From: [Dan Schroeder](#)
To: [Bailey, Heather](#)
Subject: Re: Initial review of 1015 Williamson
Date: Tuesday, April 30, 2019 1:14:37 PM
Attachments: [LP Smartside trim.pdf](#)

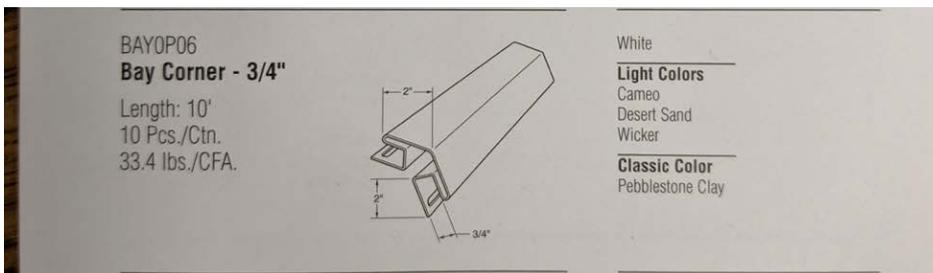
2. The head and jamb trim shall be built out to have a similar relationship to the plane of the siding and the trim shall terminate into the top of the projecting show sill. The new head and jamb trim width shall match the existing width.

The current siding will be removed and replaced, so I do not expect that the head and jambs will need to be built out. The head and jamb trim appears to be in acceptable condition, so I will be preserving those elements. In the case that any of the head or jamb trim is not salvageable, it will be replaced with trim of the exact same dimensions.
